R66-series Lead-Acid Battery Installation Upgrade Kit Instructions

KI-262-1 for installation on R66 helicopters S/N 0003 thru 0519;

(To comply with R66 Service Bulletin SB-28)

FIGURE 8 Installation of A780-78 cable
(Aft-left seat back removed)

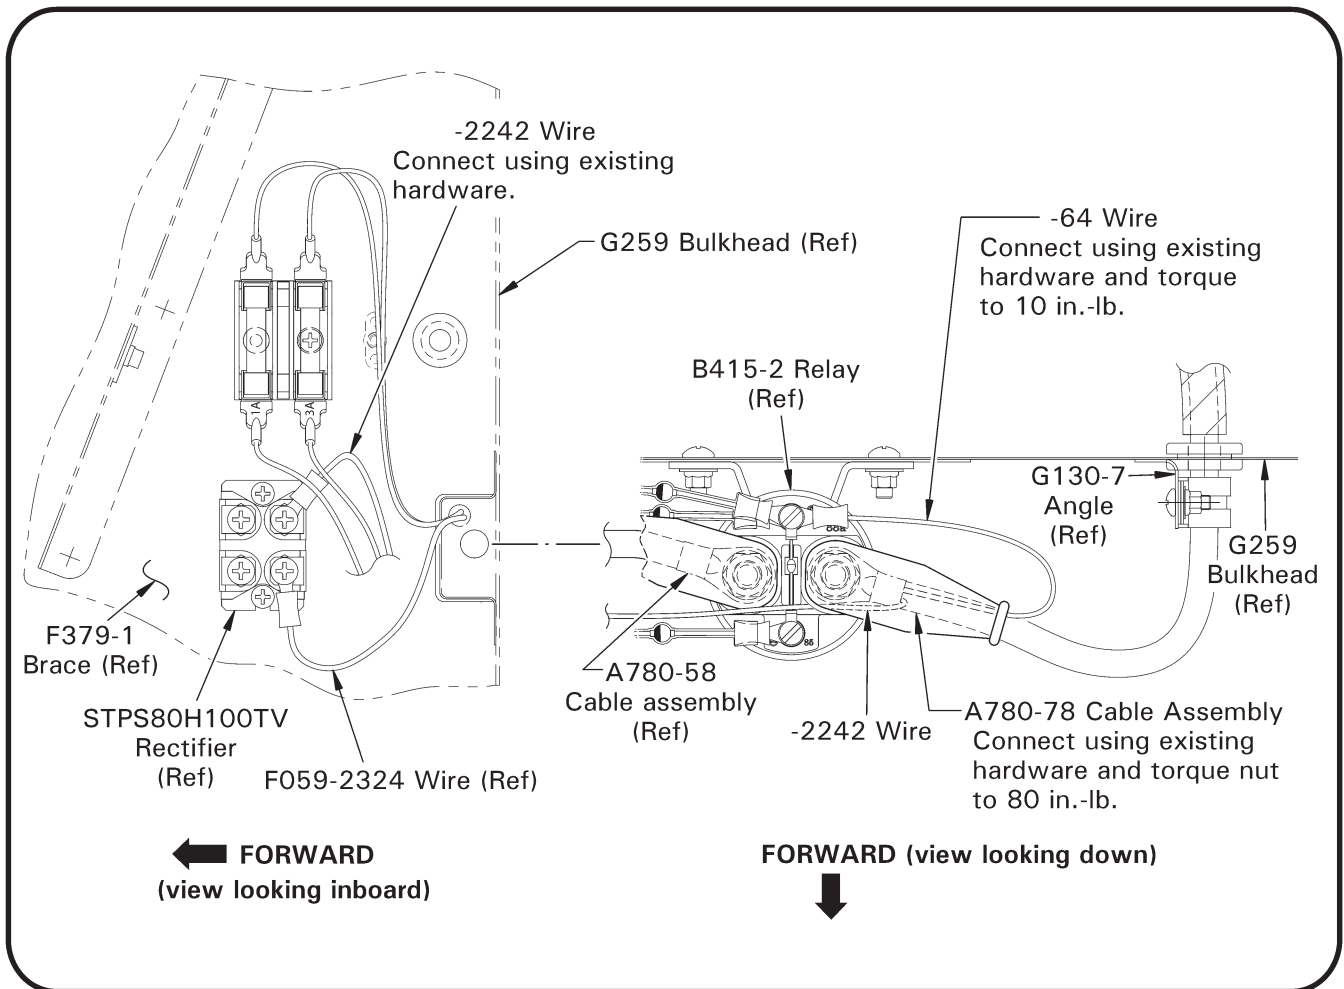
13. Refer to Figure 7 or 8, as applicable. Position MS25171-2S nipple onto relay end of replacement cable. Connect A780 cable to battery relay outboard stud and special torque nut to 80 in.-lb; verify security. Torque stripe per MM Figure 5-1 and position nipple over stud. Connect cable's -64 wire to relay terminal "86 +" and special torque screw to 10 in.-lb; verify security. **For A780-78 cable:** see Figure 8. Connect cable's -2242 wire to rectifier; verify security.
